Pentavia, Mill Hill

Planning Addendum
May 2019

GLA COMMENTS SUMMARY

Comment 2.2 - Roof plan with private roof garden spaces

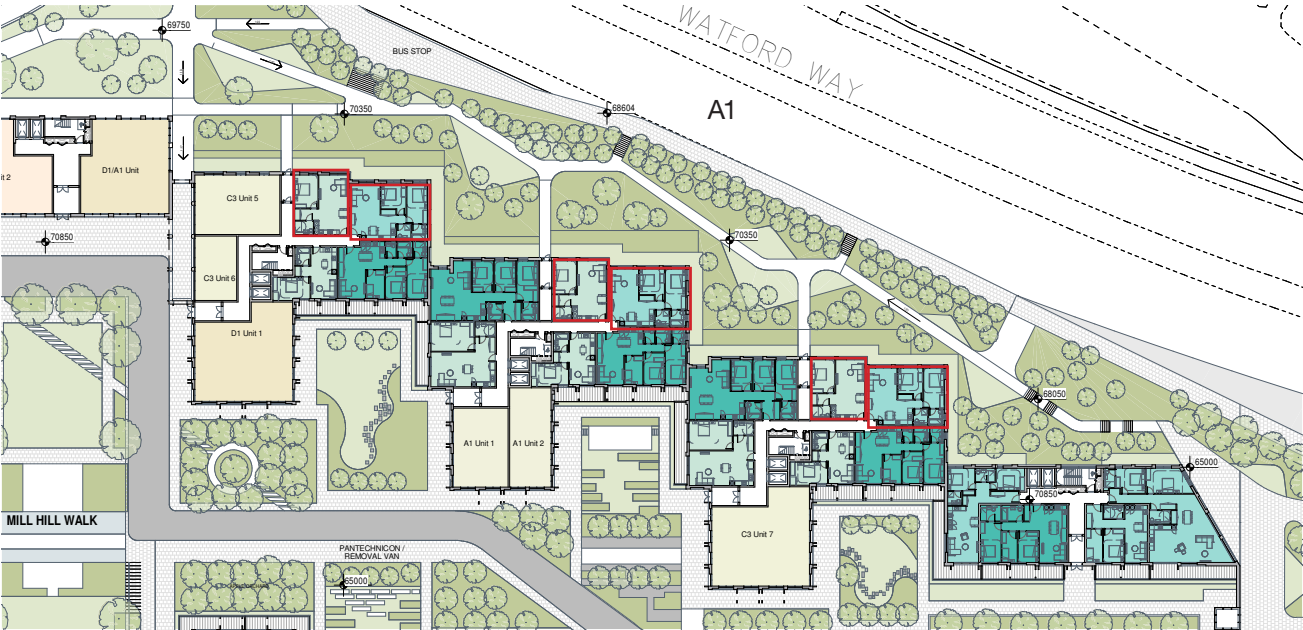
- Absence of outdoor private amenity space serving each individual unit will only be accepted where there is a clear and justifiable reason and in line with the following hierarchy:

- Currently, it is evident that a total of 161 units do not have private amenity space (19%). This is unlikely to be supported, unless it is clear that the amenity space provision has been fully maximised for each unit and there is a clear rationale provided to explain why units do not have this, and how much additional internal floorspace they have by way of compensation. I need to be able to easily explain this to the Mayor during the Hearing.

- From the 844 units, 836 (99%) have balcony/winter garden/ defensible space. The 8 units remaining that don't have private amenity (located facing A1 at Ground floor) are compensated with extra internal floor space.
- From the 836 units, 504 have the minimum external private amenity area required. From the 332 remaining, 278 are compensated with extra internal floor space.
- The remaining 54 (all types 2B A.02/2B A.03) are compensated with private roof garden.

Comment 2.3 - Updated Balconies and Winter Gardens Notation (Level 03)

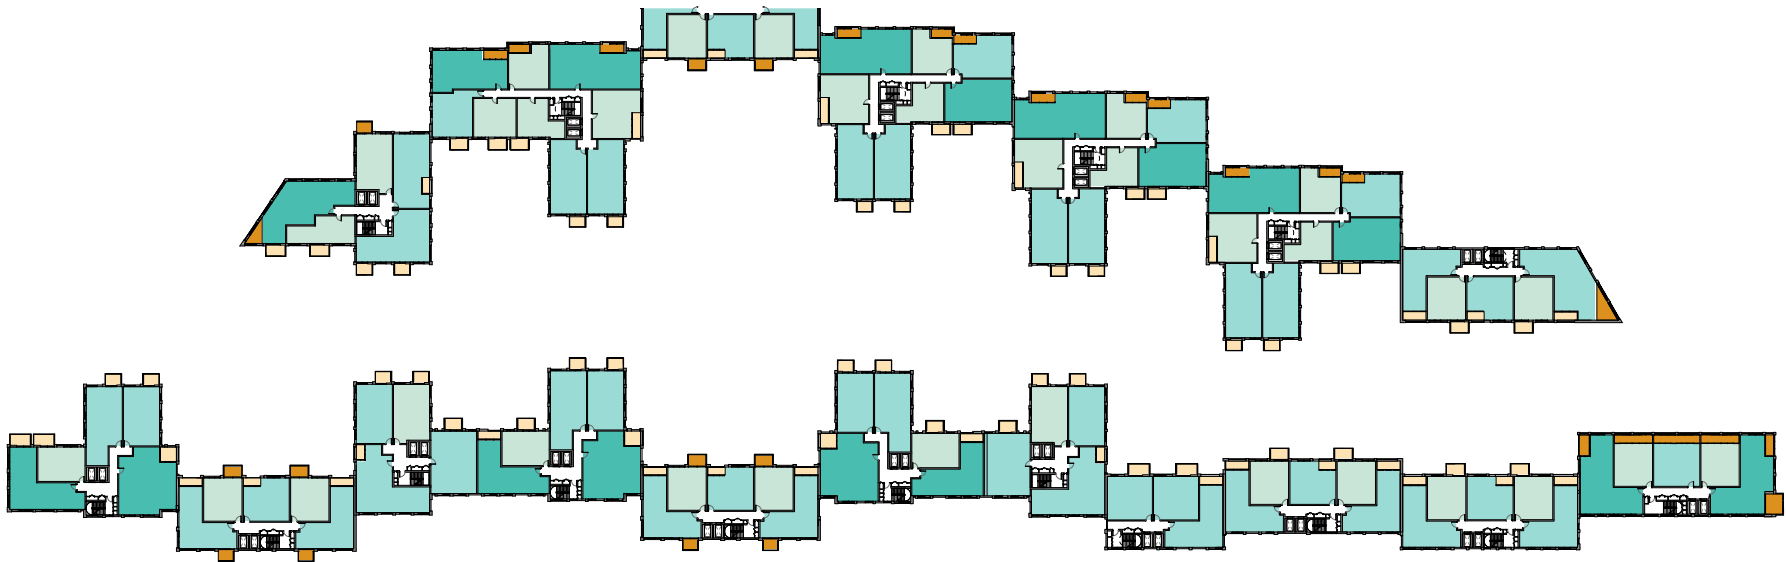
- Floorplans need to specify whether private amenity space serving individual units is in the form of a balcony or winter garden as this is unclear and can only be verified by cross-checking elevations on each façade.

- We have made this clear on the drawings and used a key to denote which is which.

Comment 3.1 - Updated Overall Plan (Ground Floor) with revised residential entrances

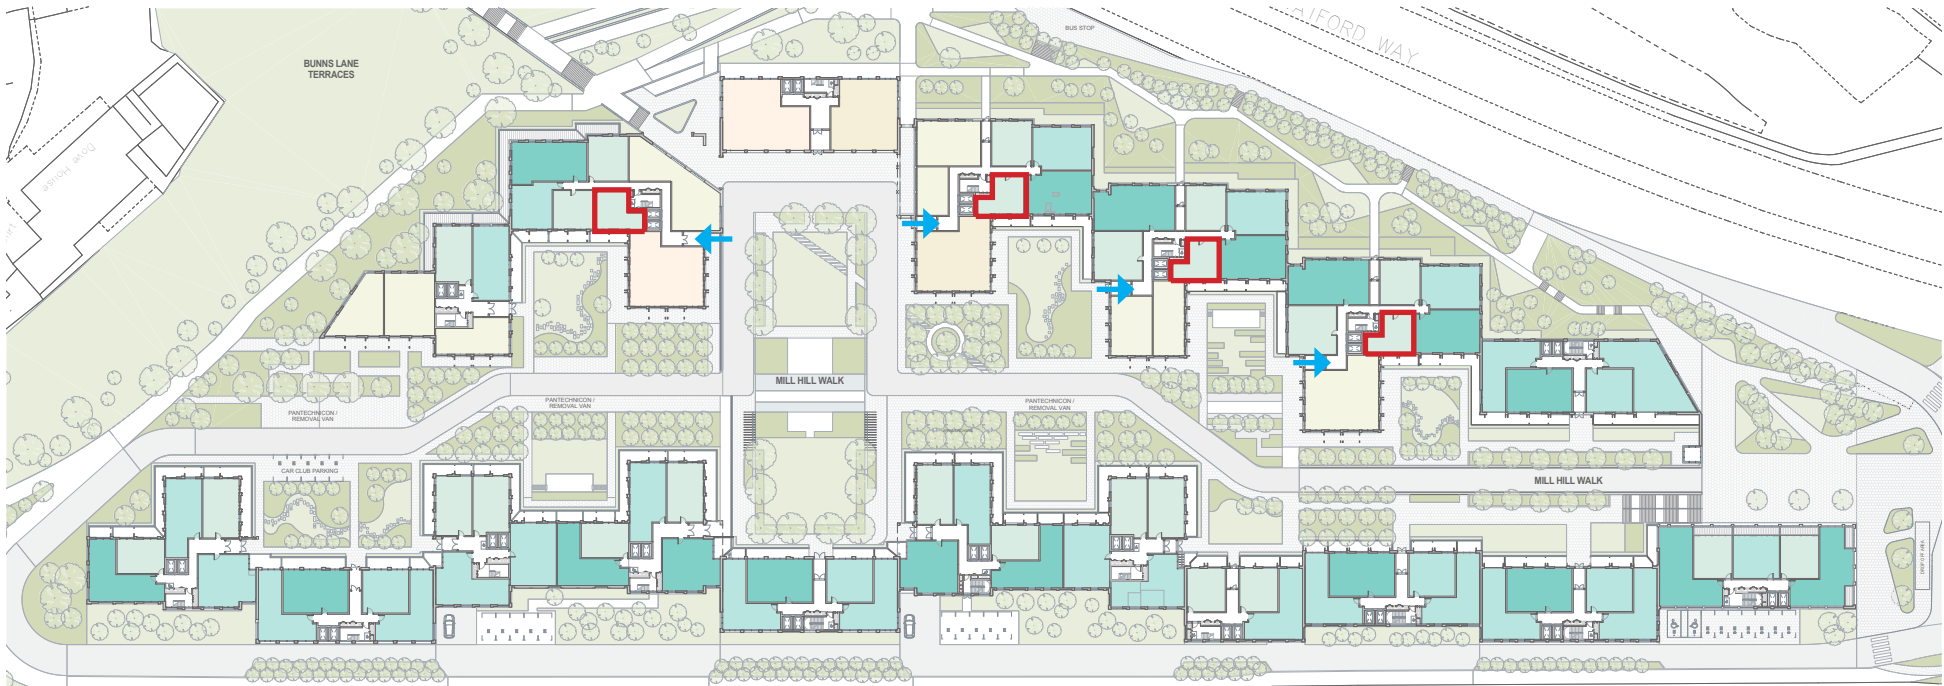
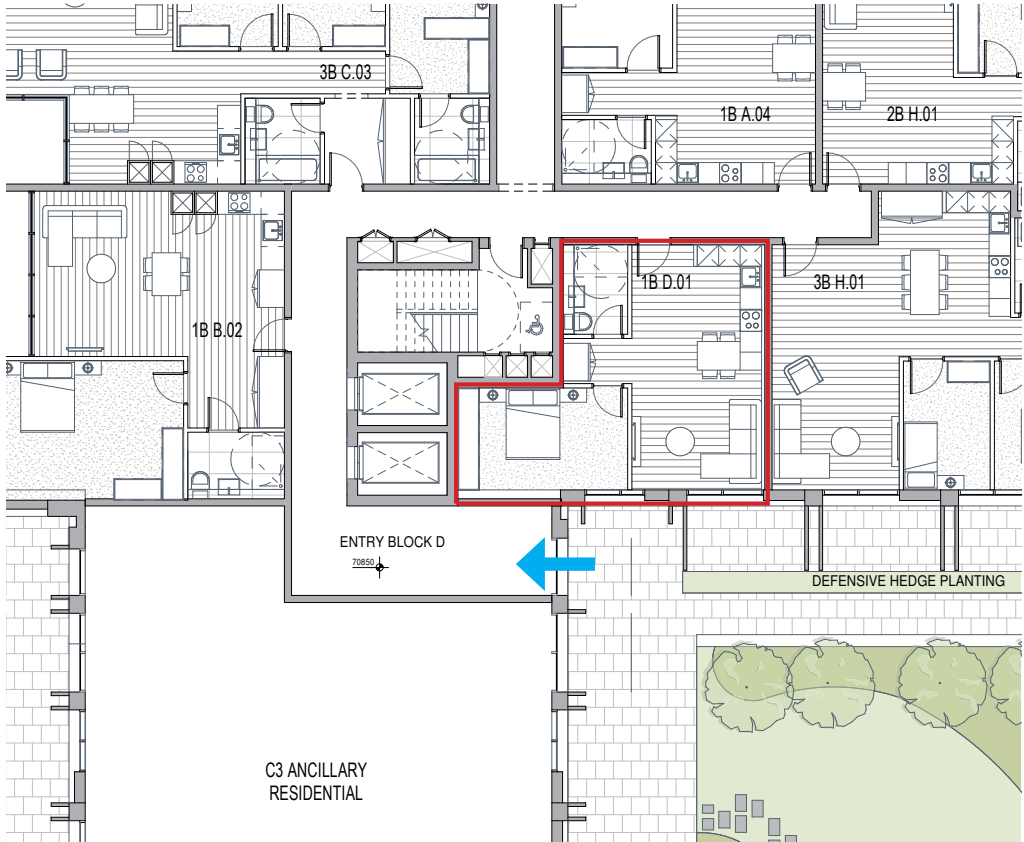
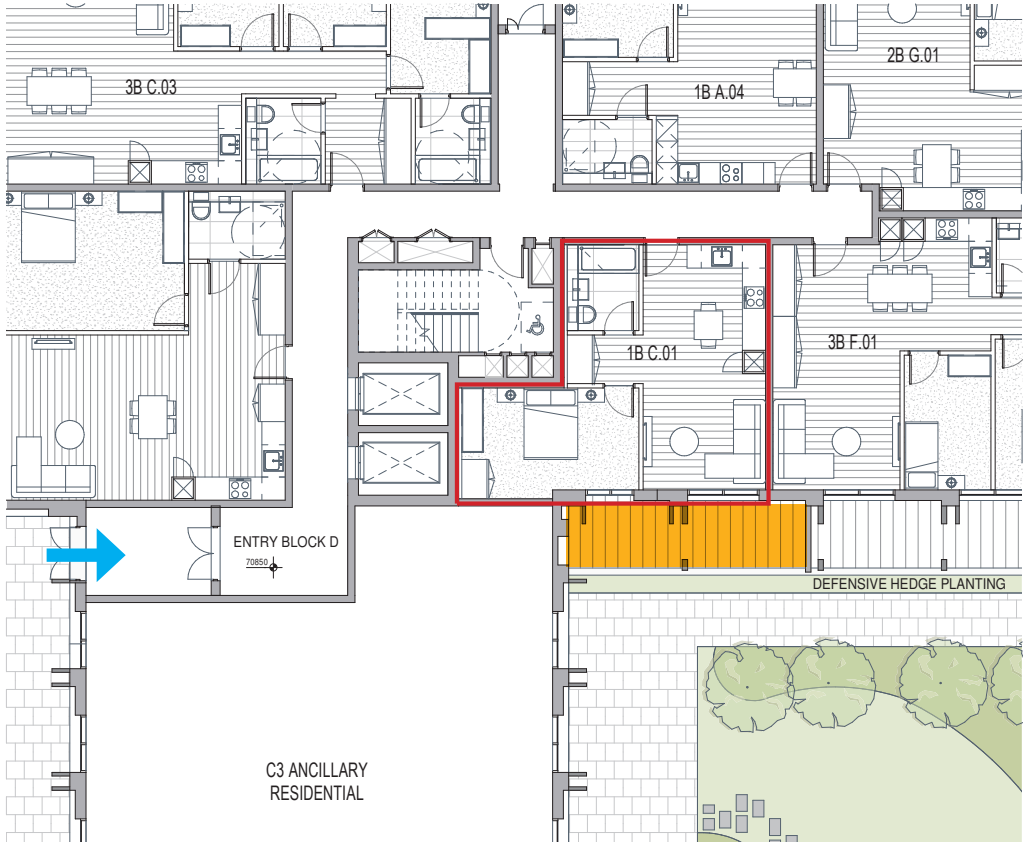
- At ground floor level, there are a number of instances in which units within the corner of courtyards spaces are located immediately adjacent to communal core entrances. In all of these instances, the units are not provided with any defensible private amenity space or landscaping as a buffer. To address this, the residential cores need to be moved slightly away from these units and private defensible space provided to ensure ground floor bedroom windows are not overlooked and compromised.

- Residential core entrances - have been move around to so private residential defensible space is ensured and overlooking not compromised.
- Defensible spaces – Further definition to defensible spaces and entrances have been made which link to each unit on the ground floor. (Also, please refer to further site wide defensible space changes on Comment 3.1)

- Revised ground floor entrance location
- Revised defensible space configuration

Comment 3.2 - Updated Overall Plan (Ground Floor) with revised defensible zone

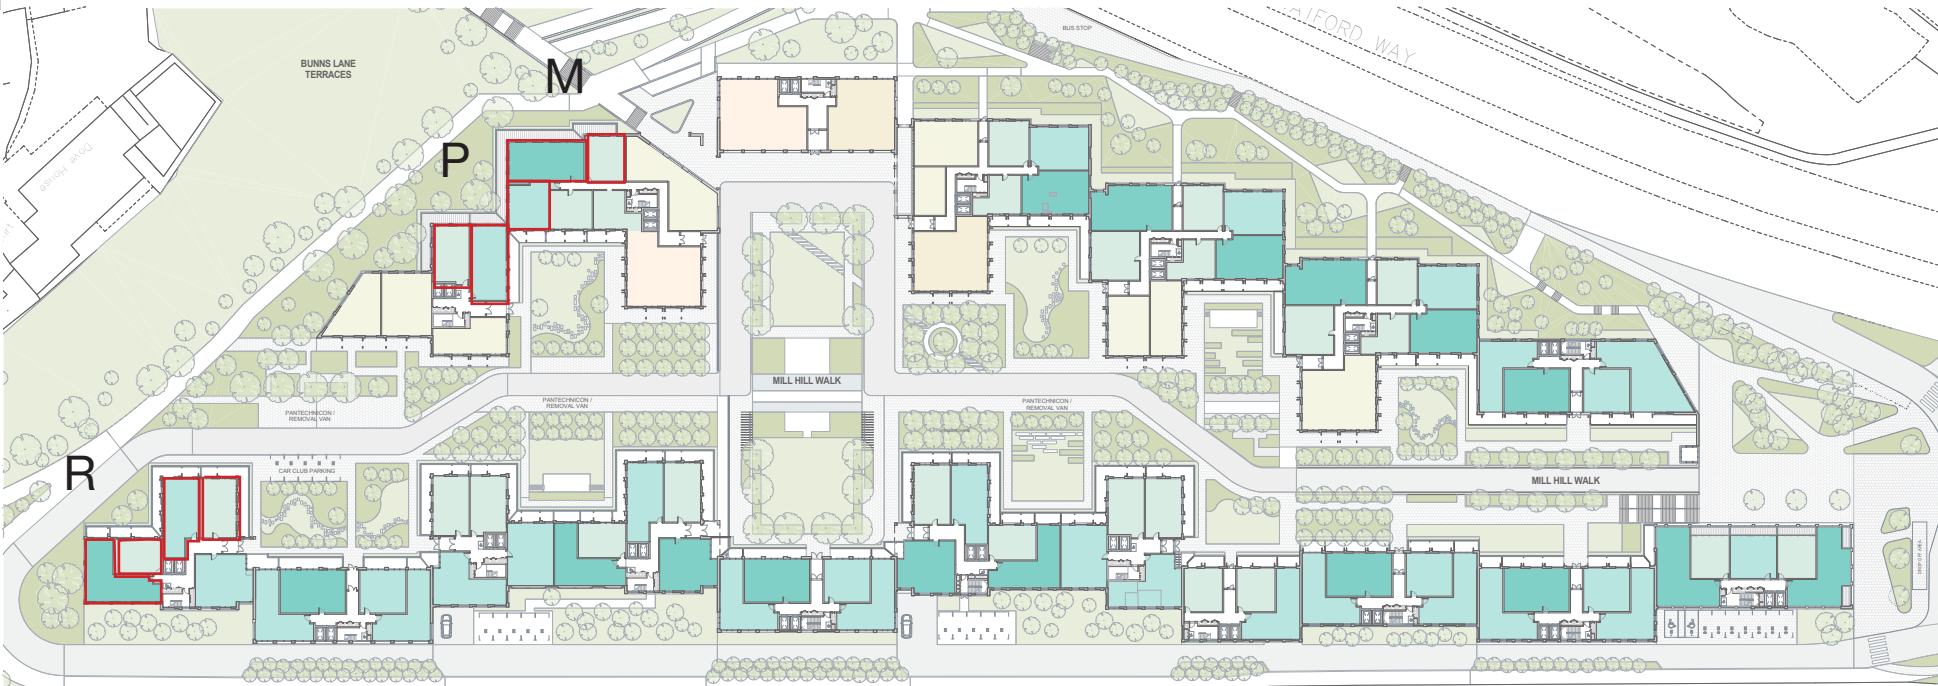
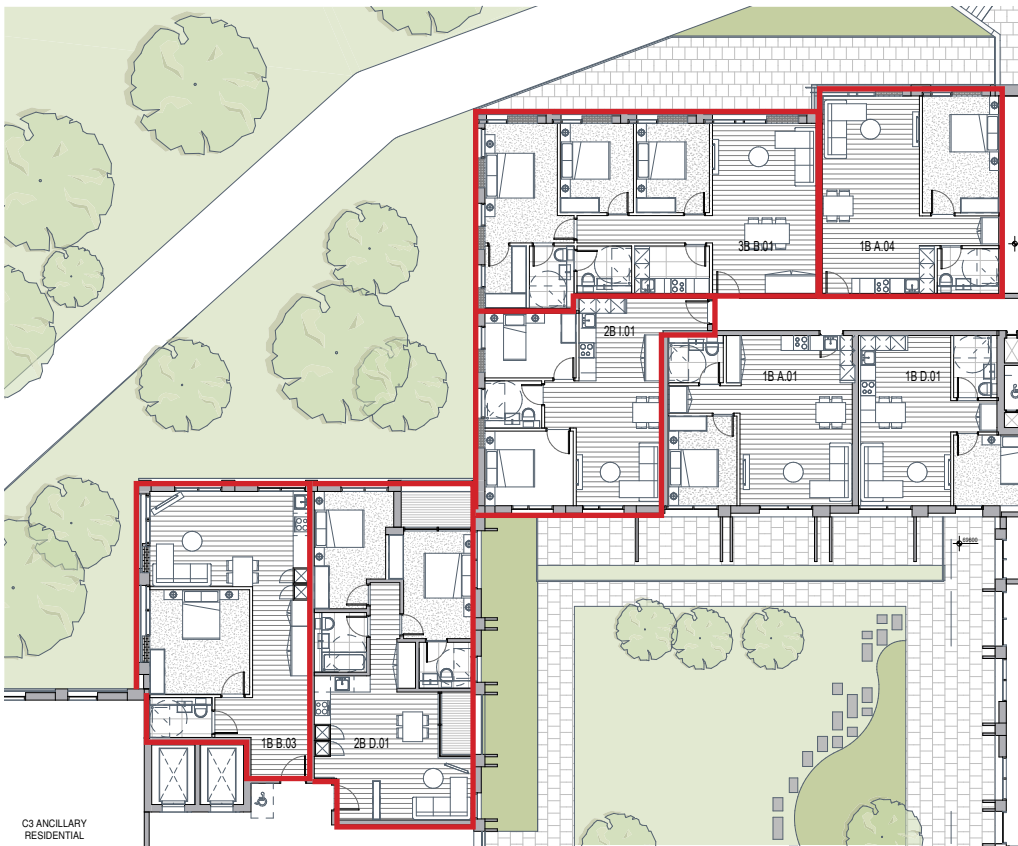
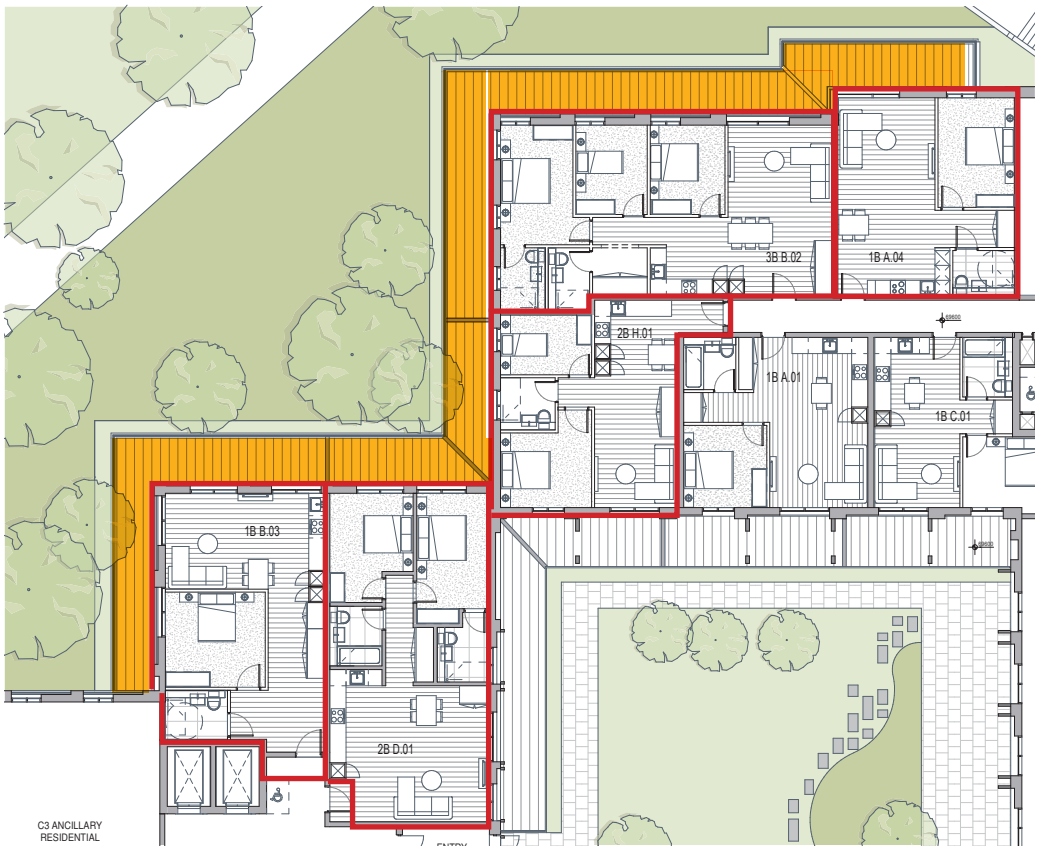
- See Block, P and M facing Bunns Lane and the site's northern boundary

- Block P, M & R – we have added a defensible zone along this edge for privacy between units and adjacent pedestrian and cycle path.
